HCISD Performing Arts Design Committee Meeting

MEETING MINUTES

PROJECT: HCISD PAC

PROJECT #:1027

C. Sections

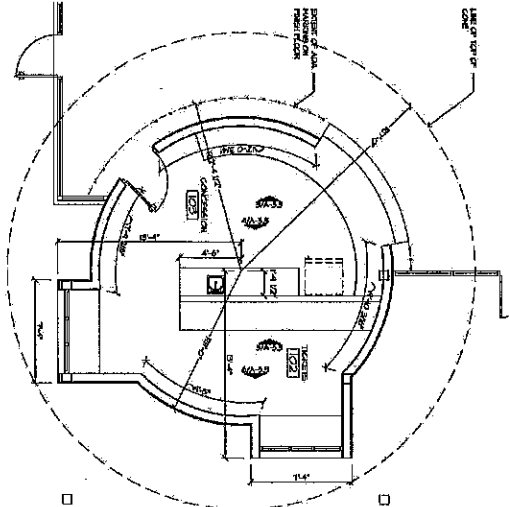
- Heights of lobby, auditorium, and support rooms are lowered approximately 2 feet in an effort to save material cost.
